Ministerial Referral: TPM-2015-4

Wesley Church Complex, 118-148 Lonsdale Street, Melbourne

**PLANNING REPORT****MINISTERIAL REFERRAL**

<b>Application number:</b>	<b>TPM-2015-4</b>
<b>DELWP Application number:</b>	2015/7000
<b>Applicant / Owner / Architect:</b>	Leighton Properties C/- Urbis Pty Ltd / The Uniting Church in Australia Property Trust (VIC) / Cox Architecture
<b>Address:</b>	Wesley Uniting Church, 118-148 Lonsdale Street, MELBOURNE VIC 3000
<b>Proposal:</b>	Demolition of existing buildings and construction of a multi-storey building including buildings and works within the Tree Protection Zone
<b>Cost of works:</b>	\$200 million
<b>Date received by City of Melbourne:</b>	22 January 2015
<b>Responsible officer:</b>	Kate Yuncken
<b>Report Date:</b>	20 November 2015
<b>(DM#9409536)</b>

**Lonsdale Street Section  
Current 2015 Planning Application**

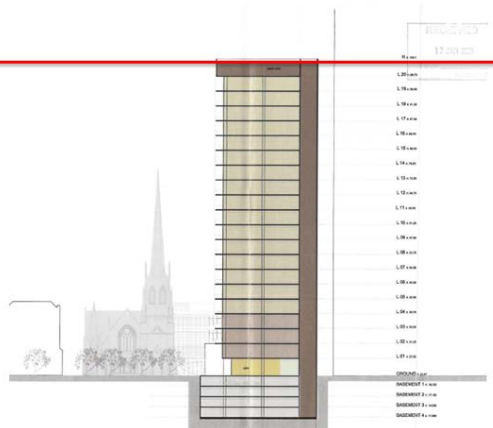
It is acknowledged that the proposed building is significantly higher (148.4 metres compared with 80 metres) and larger (in that the proposal does not incorporate the street setbacks that the previous planning permit application proposed) (TPM-2009-2), which was refused by the Minister for Planning on 19 January 2011. The refused application was subject to Design and Development Overlay 56 which has been removed from the Planning Scheme. It is considered that the visibility of the tower walls to Lonsdale and Little Lonsdale Streets is the primary concern and not the proposed height of the building.

The built form is acceptable if a minimum 5 metre tower setback to the streets is introduced.

**Jones Lane Elevation and Section**  
**Current 2015 Planning Application**

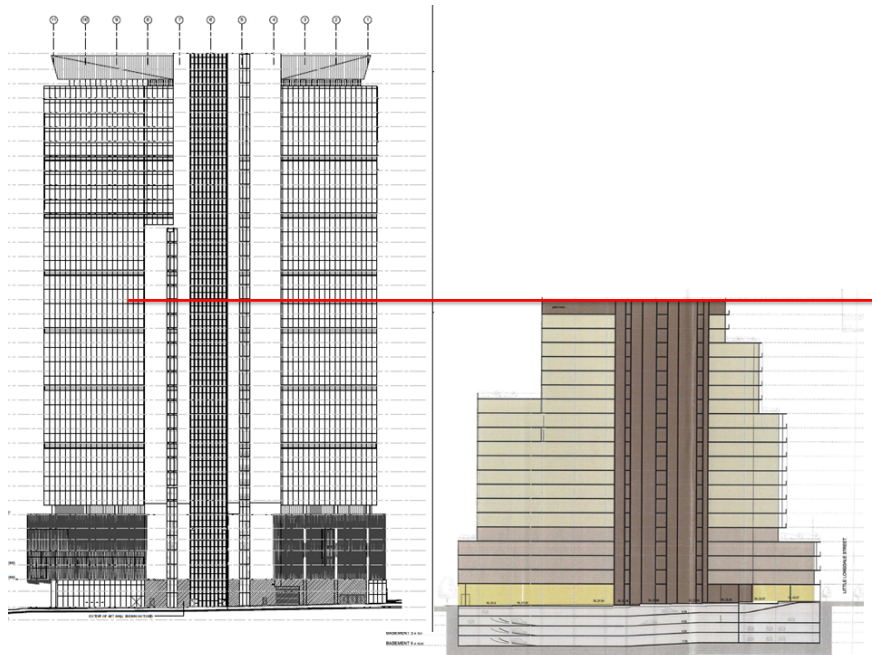
The previous planning permit application (TPM-2009-2), which was refused by the Minister for Planning on 19 January 2011, had no setback to Jones Lane. The grounds of refusal included that the proposal, 'results in the loss of residential amenity to the properties to the east of Jones Lane beyond that which could reasonably be expected in the City'.

Although the proposed building is significantly higher (148.4 metres compared with 80 metres) than the previous planning permit application, a two metre setback is proposed resulting in a tower separation of approximately 10 metres. It is acknowledged that the level of amenity to the Regency Towers will be impacted by the proposed building however the impact is not unreasonable when considering that overlooking opportunities have been minimised through the location lift core and services on the Jones Lane elevation and the fact that there is a public lane between the buildings.
